Newton County Regional Water and Sewer District

Newton County, Indiana**Wastewater Collection and Treatment System****Addendum No. 4****September 2, 2009**

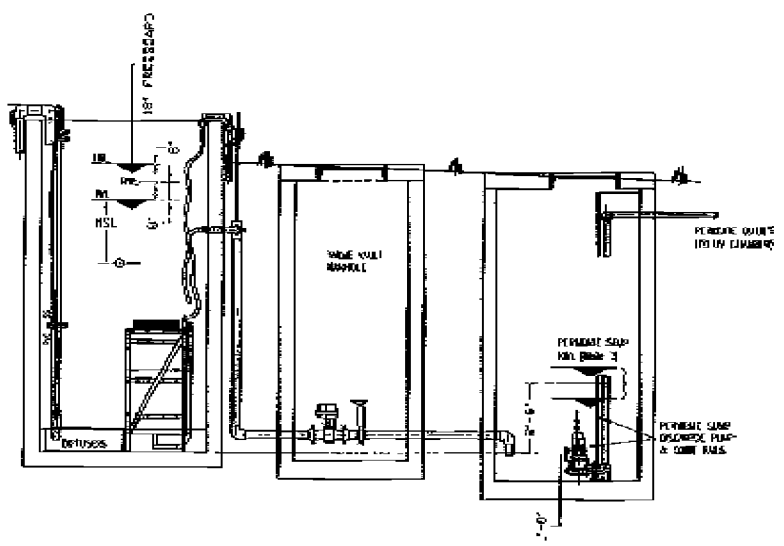
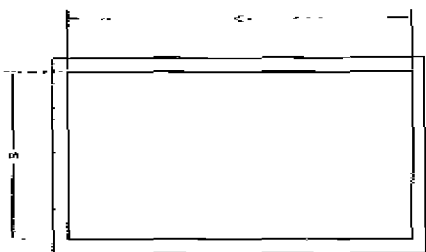
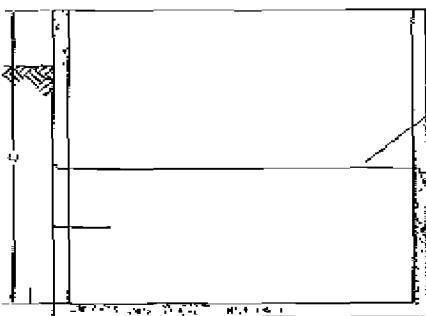
A scope of supply for the Bord na Mona system is attached to this addendum along with four (4) general drawings showing information on the Bord na Mona MBR system proposed layout. The scope of supply and drawings are intended to provide Bidders a better understanding of the plant configuration if Bidder selects Activated Biological Process System Option B. Contractor is still required to supply a telescoping valve and drain line in the sludge holding tank. Bidders may obtain 11x17 size drawings of the Bord na Mona general drawings by contacting Marbaugh.

Tabulation of Equipment Items forming the Basis of Bid Table

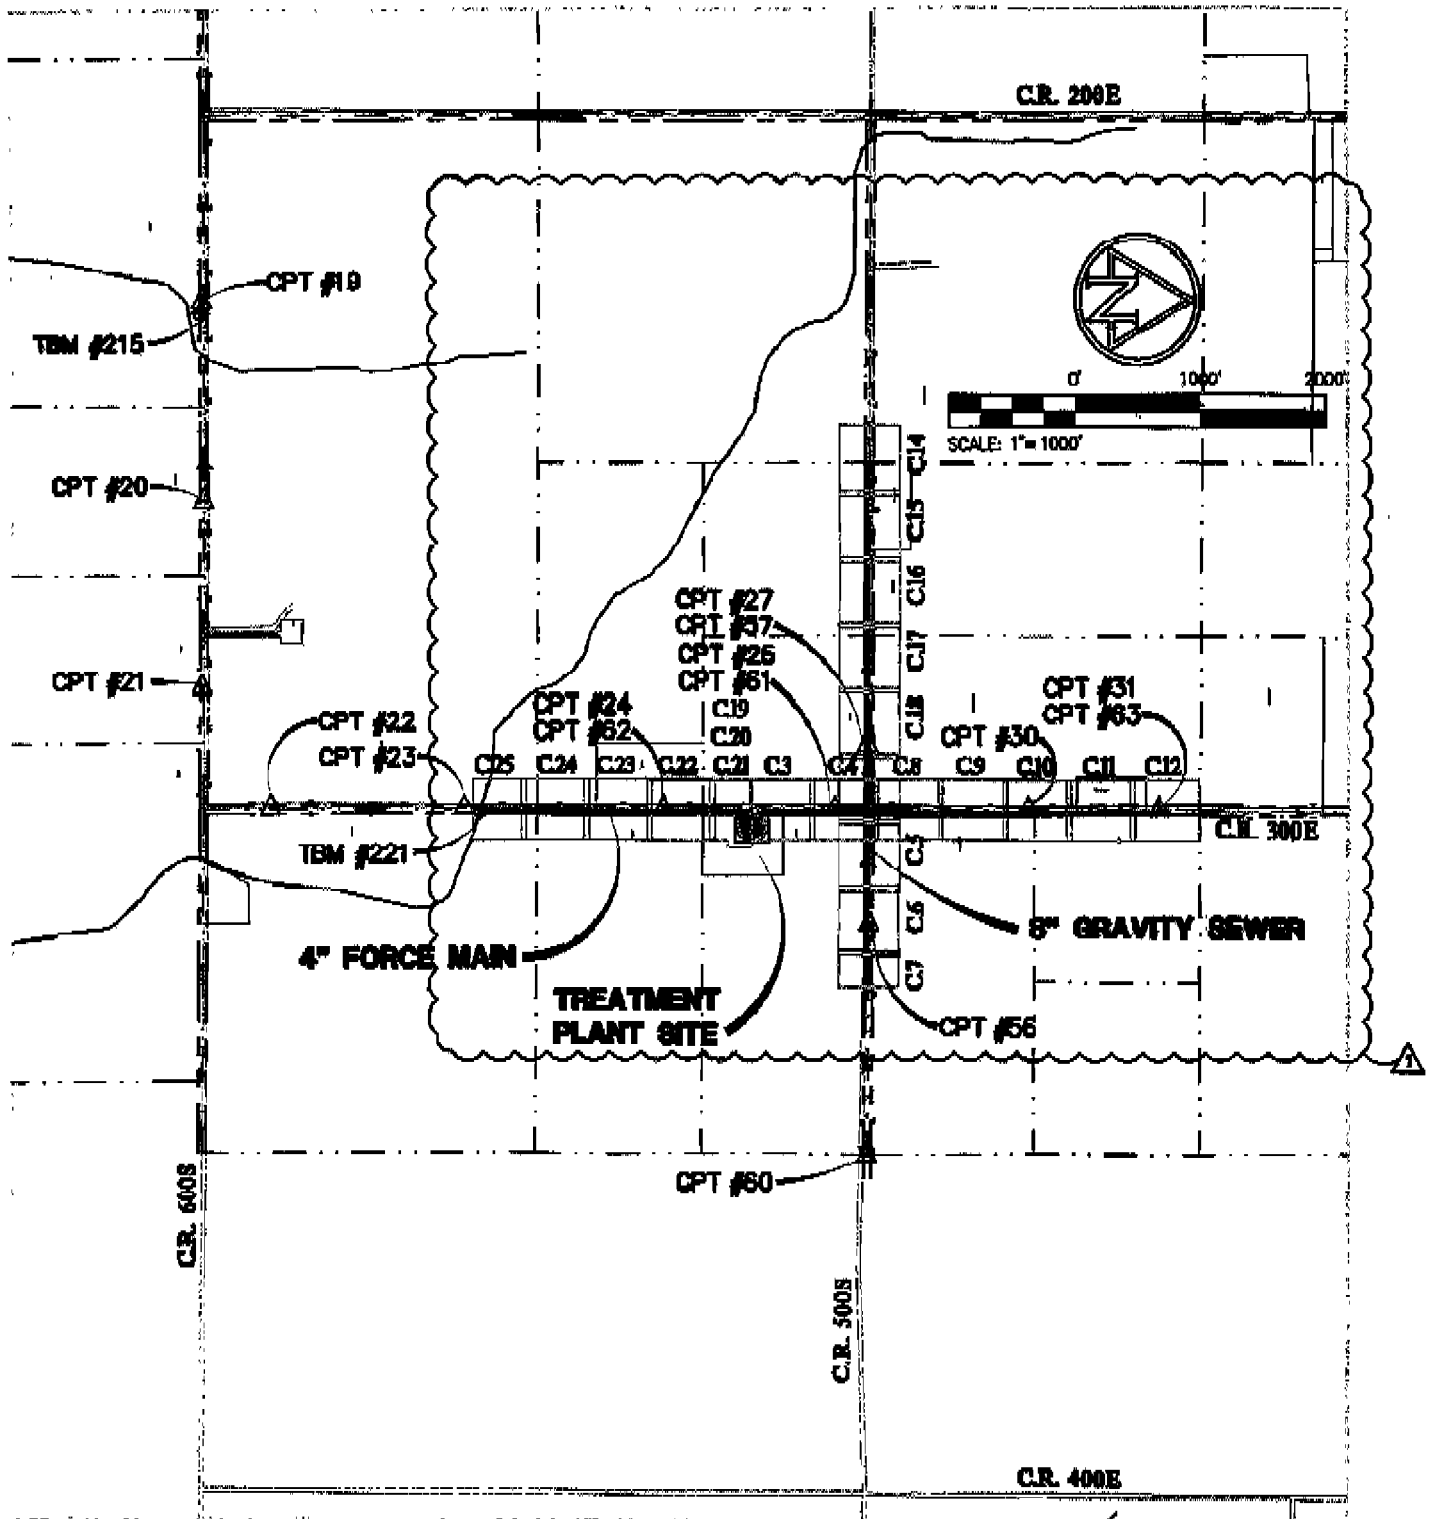
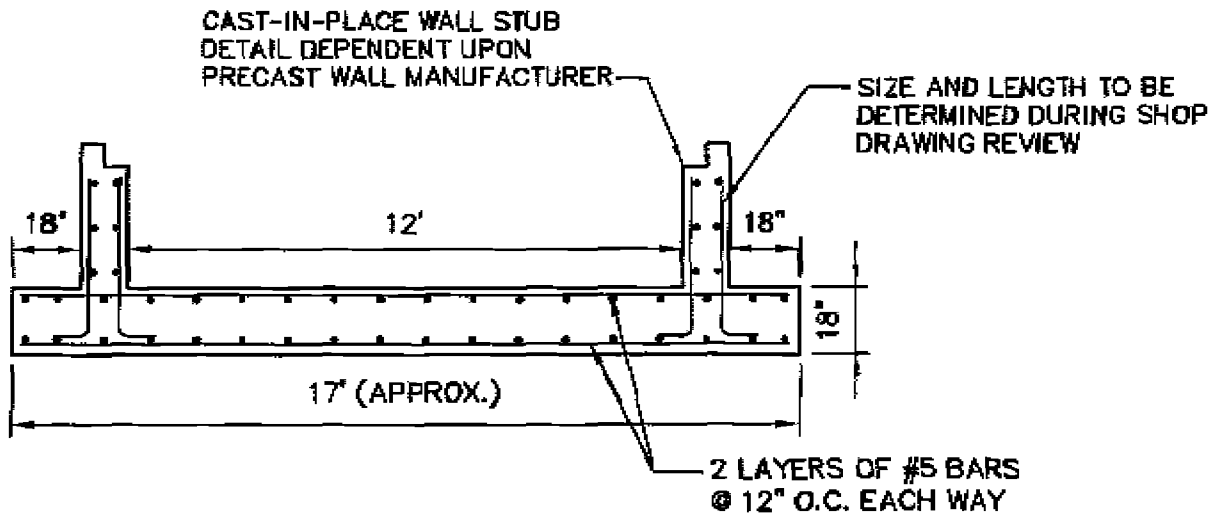
1. **REPLACE** the Tabulation of Equipment Items forming the Basis of Bid Table in the Bid Form (Page 5 of 9) with the attached revised Tabulation of Equipment Items forming the Basis of Bid Table. Parkson Rotoshear drum screen model HRS2448DV has been added to the table as an equal to JWC Environmental.
